**Tennessee Valley Authority
Regulatory Submittal for Kingston Fossil Plant**

**Documents submitted:
Construction/Operation of Excavation/ Working Platform Extended Platform on Lateral
Expansion - Revision 1**

CONSTRUCTION/OPERATION OF EXCAVATION/WORKING PLATFORM/EXTENDED PLATFORM ON LATERAL EXPANSION-REV. 1

Re: Geotechnical Evaluation
Construction of Working Platform and
Ash Excavation Lateral Expansion
Kingston Fossil Plant
Harriman, Roane County, Tennessee

SKETCH LE-2-16
2-16-2010

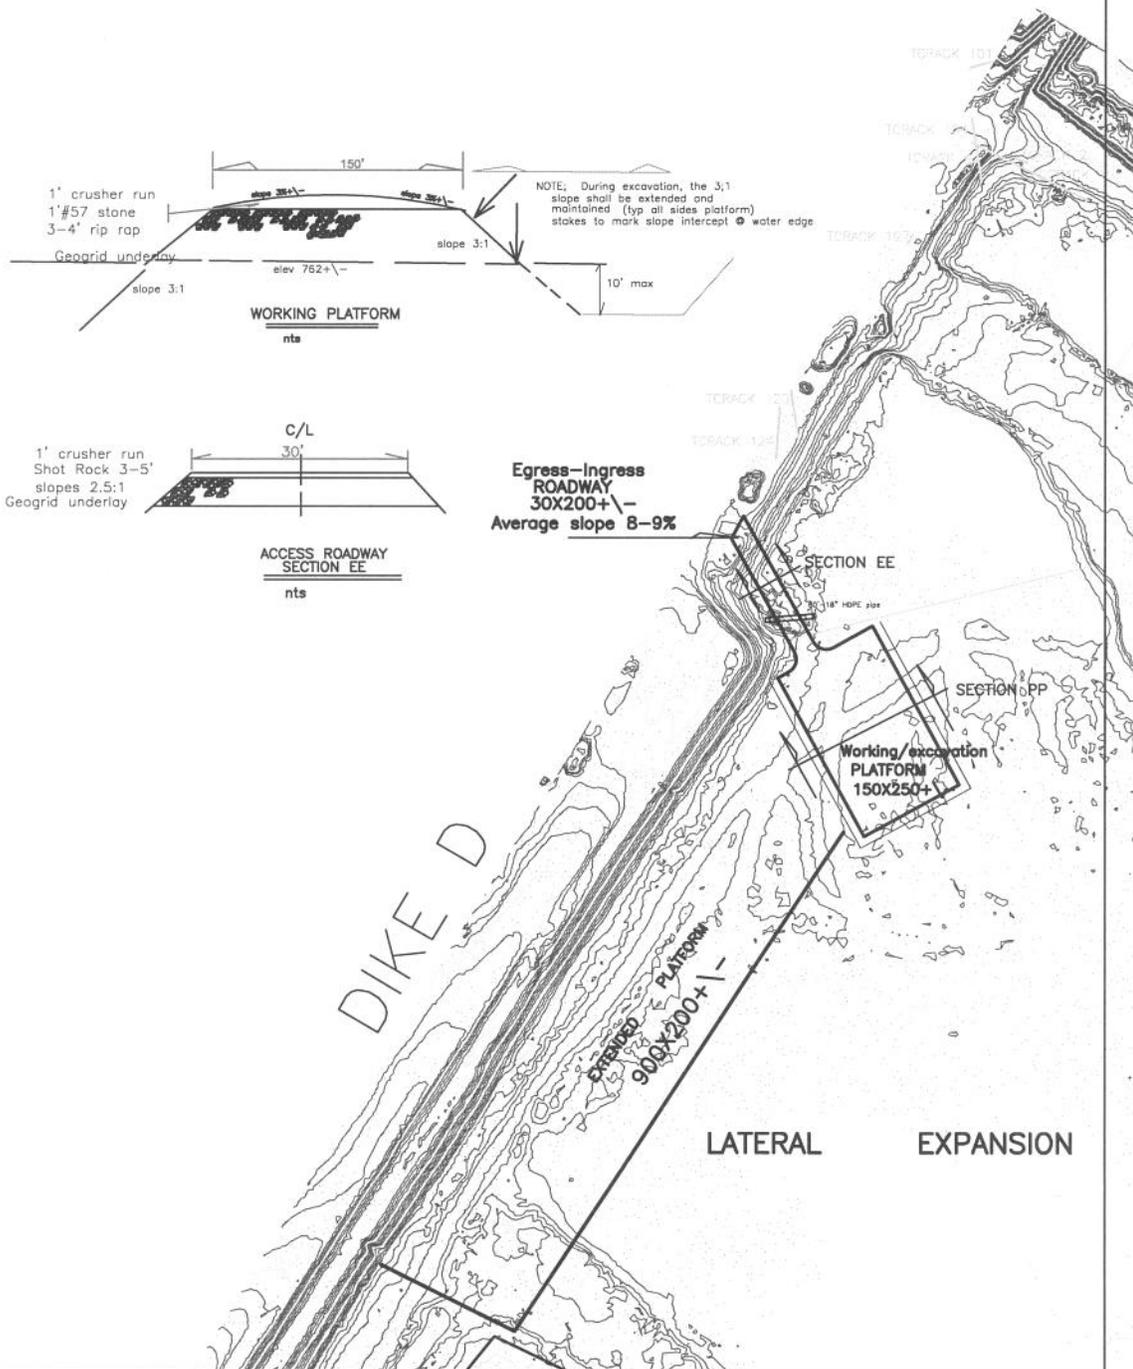
Stability analysis of the operation indicates that the required short term factors of safety are maintained with a working platform thickness ranging from three to six feet, depending on the conditions realized during construction within the existing hydraulically placed ash foundation materials. Recommended platform metrics are provided below:

- Maximum outslope: 3:1 (Horizontal:Vertical);
- Materials: Zoned durable aggregates overlying geogrid base reinforcement;
- Initial Minimum Platform Thickness: Six (6) feet (subject to field-adjustment by the engineer).

Following engineer's approval of the working platform, ash removal will be accomplished through mechanical dredging with amphibious track-hoes. The excavation will be oriented along the northern and eastern limits of the platform following the metrics below:

- Excavation side slopes: 3:1 or flatter;
- Maximum depth: 10 feet;
- Maximum differential of one (1) foot between water level maintained in excavation and surrounding grade.

Stantec concurs per the following criteria:

- The excavation be maintained 65 feet east of the Dike D toe of slope.
- The max 6-foot high fill line should be staked in the field along the outslope of Dike D for operator reference.

- Outslopes within the excavation and resulting back stacked ash material should be maintained at 6:1 or flatter.
- Max. stacked ash height is 6-feet unless approved by Stantec.

- The excavation should extend parallel to Dike D from the vicinity of the existing Lateral Expansion Ash Processing Platform and end 150 feet north of the Lateral Expansion dike within the vicinity of the outlet weir. The intent of the 150-foot offset from the weir is to reduce potential scouring effects from subsequent dredge water flows.

Jim and I have reviewed and Stantec approves Rev 1.
Thanks.
